STATE OF UTAH
DEPARTMENT OF NATURAL RESOURCES
DIVISION OF OIL, GAS AND MINING

APPLICATION FOR PERMIT TO DRILL				5. MINERAL LEASE NO: ML-21329	6. SURFACE: State
1A. TYPE OF WORK: DRILL <input checked="" type="checkbox"/> REENTER <input type="checkbox"/> DEEPEN <input type="checkbox"/>				7. IF INDIAN, ALLOTTEE OR TRIBE NAME:

2. NAME OF OPERATOR: KERR MCGEE OIL & GAS ONSHORE L.P.				9. WELL NAME and NUMBER: STATE 1021-28L	
3. ADDRESS OF OPERATOR: 1368 S 1200 E CITY VERNAL STATE UT ZIP 84078			PHONE NUMBER: (435) 781-7024	10. FIELD AND POOL, OR WILDCAT: NATURAL BUTTES

STATE 1021-28L
NW/SW SEC. 28, T10S, R21E
UINTAH COUNTY, UTAH
ML-21329

APPROXIMATE TOTAL 8" PIPELINE DISTANCE = 11,950' +/-

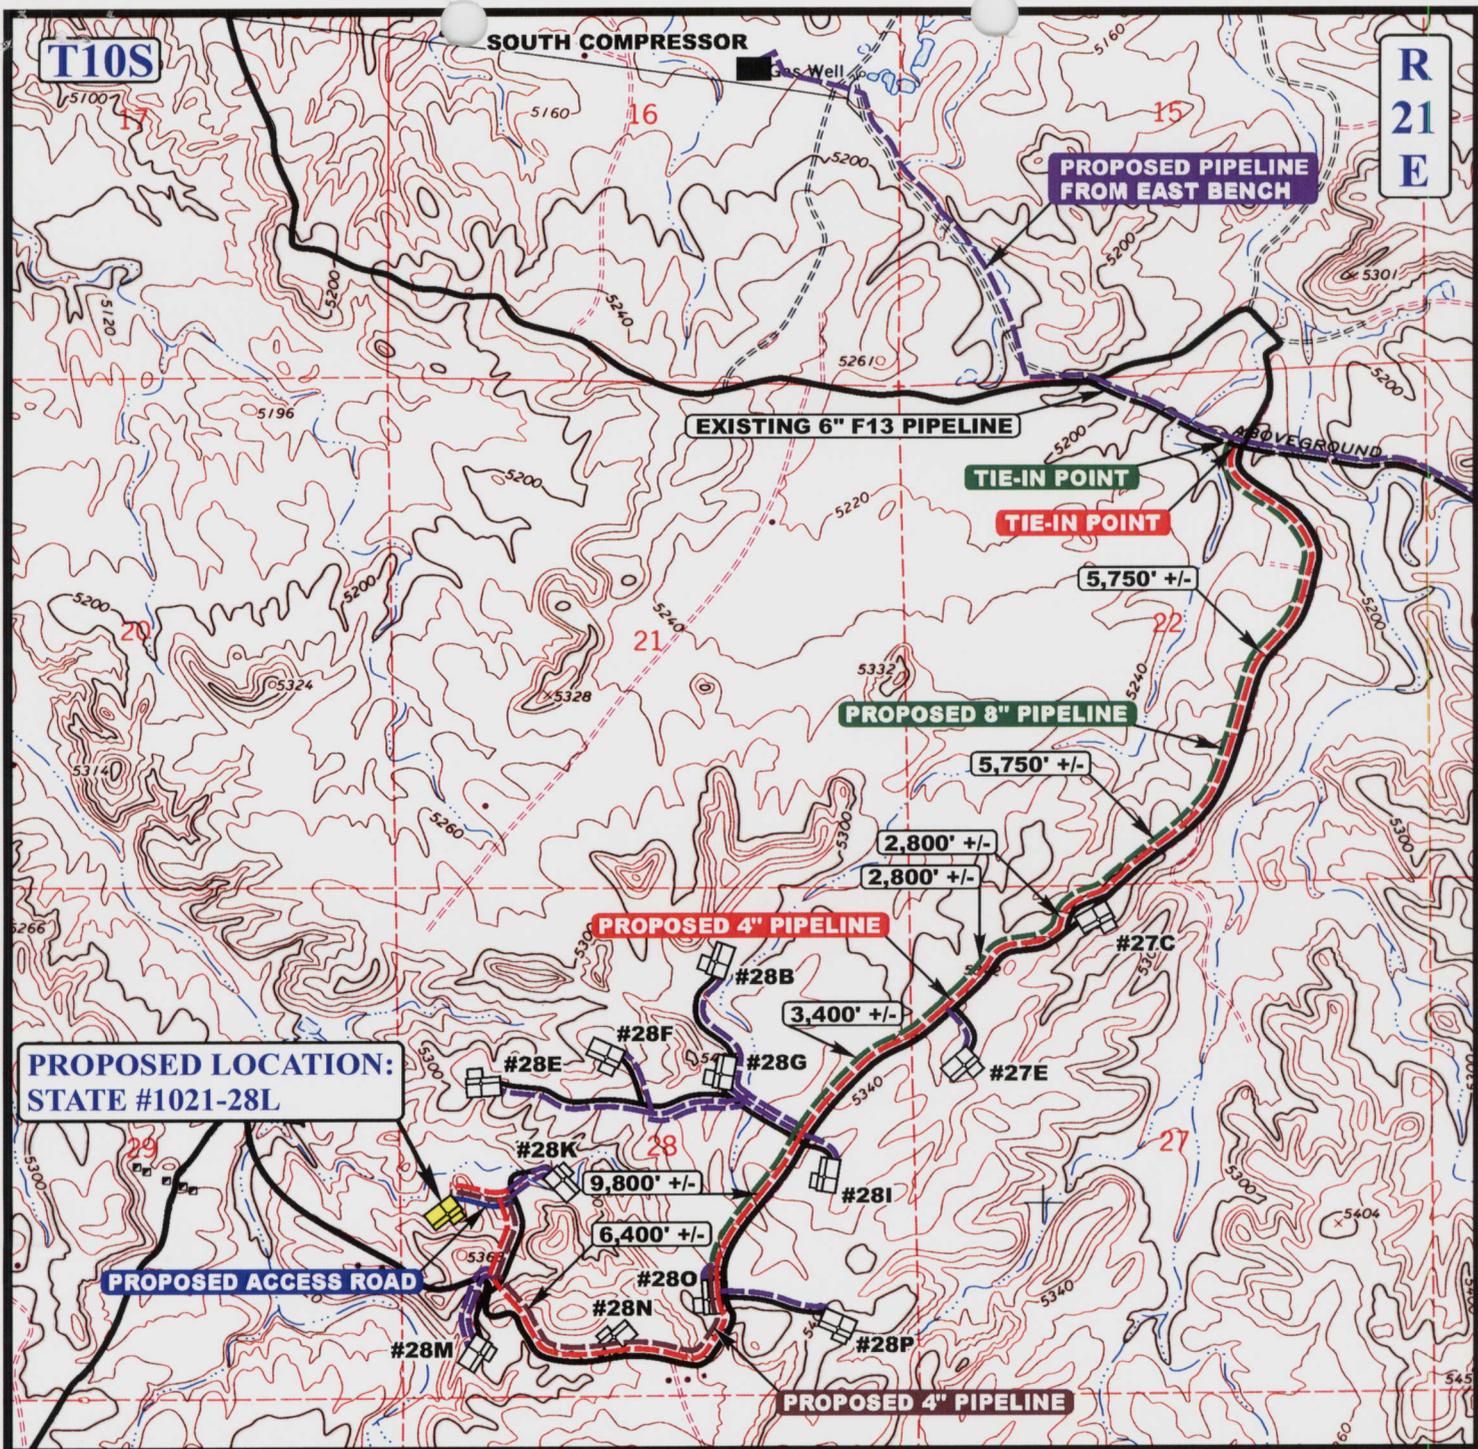
An onsite was conducted on 4/5/07 with the Division of Oil, Gas and Mining Representative and SITLA Representative. It was decided to change the proposed pipeline from a 4" pipeline that was approximately 700' +/- to, two 4" pipelines approximately 18,350' +/-, and 6,400' +/-, and an 8" pipeline approximately 11,950' +/- . These pipelines also cross onto Federal lands in Sec 27 and tie into a point in Sec 22 of T10S-R21E.

**PROPOSED LOCATION:
STATE #1021-28L**

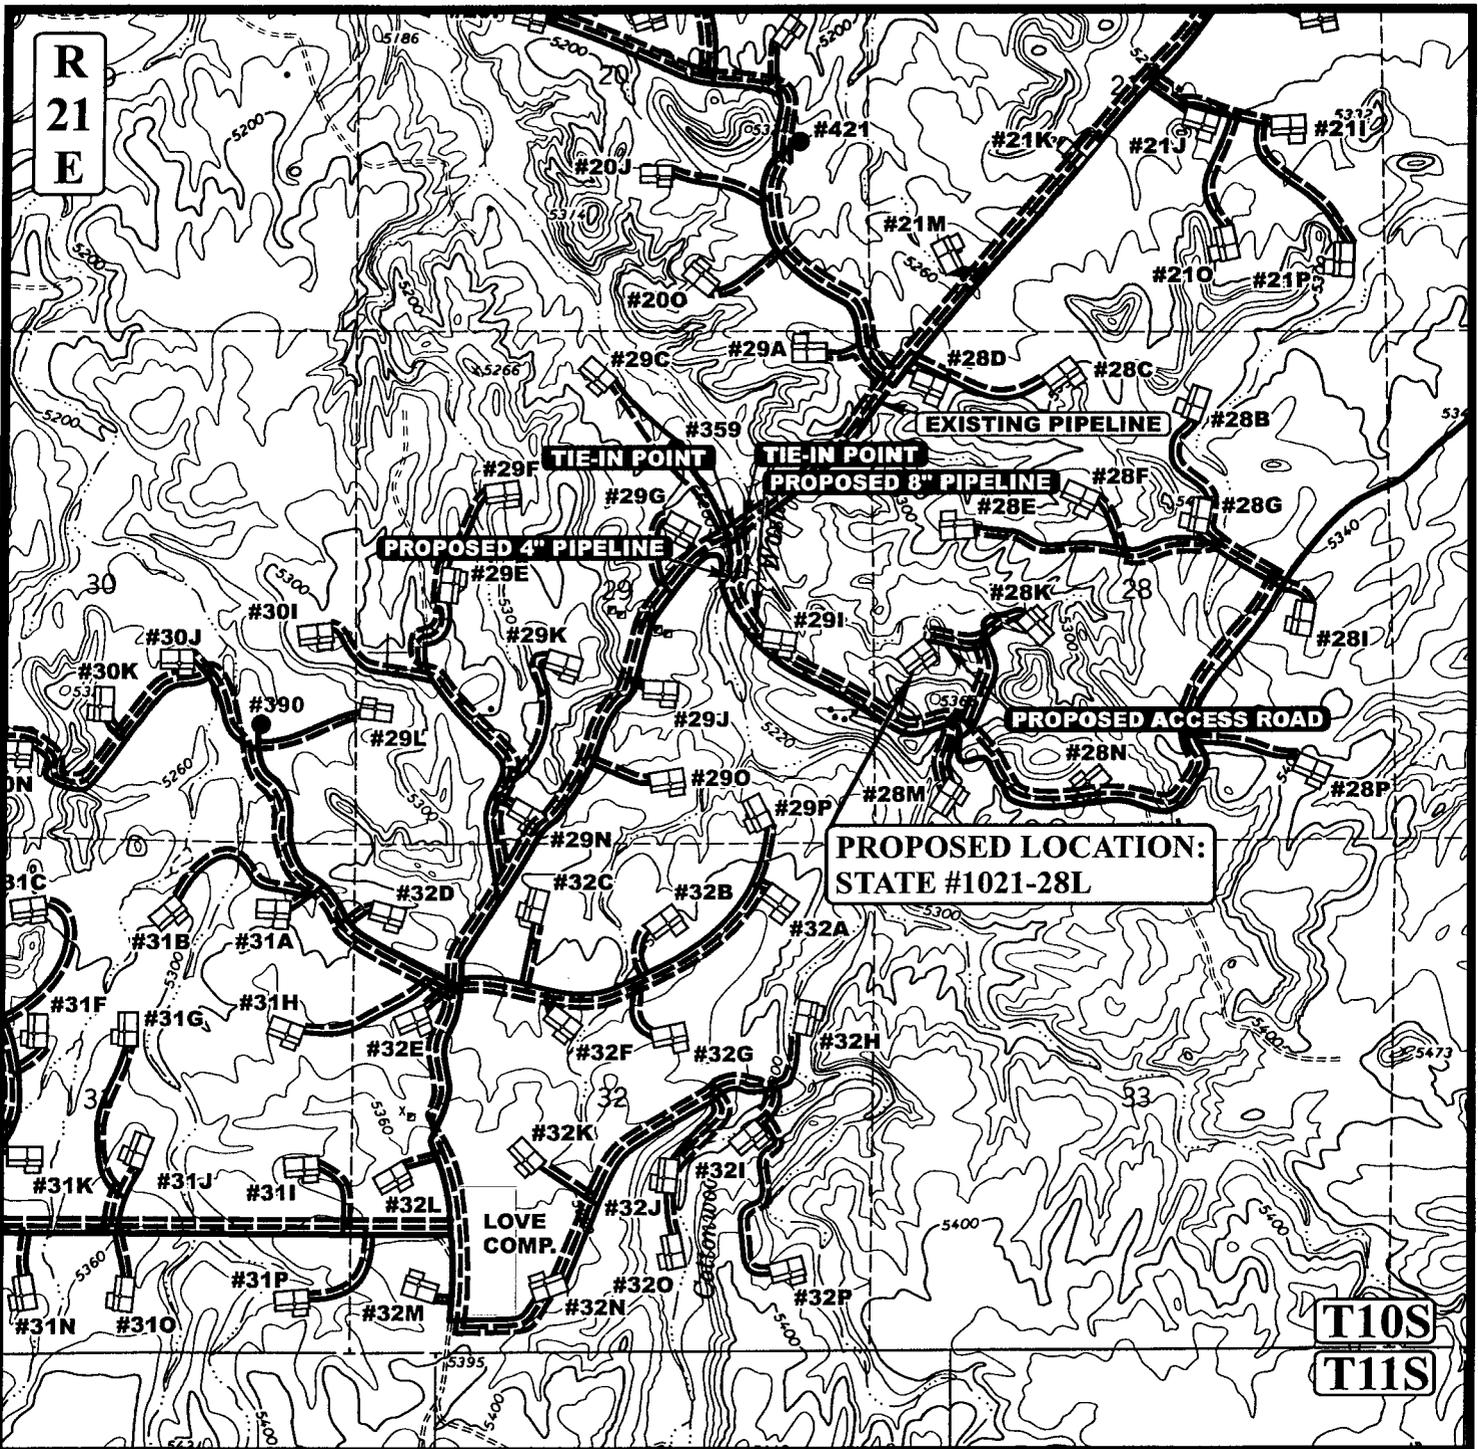
An onsite was conducted on 4/5/07 with the Division of Oil, Gas and Mining Representative and SITLA Representative. It was decided to change the proposed pipeline from two 4" pipelines approximately 18,350' +/-, and 6,400' +/-, and an 8" pipeline approximately 11,950' +/- to two 4" pipelines approximately 5,350' +/- and 1,700' +/- and an 8" pipeline approximately 3,650' +/-.

Please replace the sundry that was filed on 4/18/07 with this sundry dated 5/8/07.
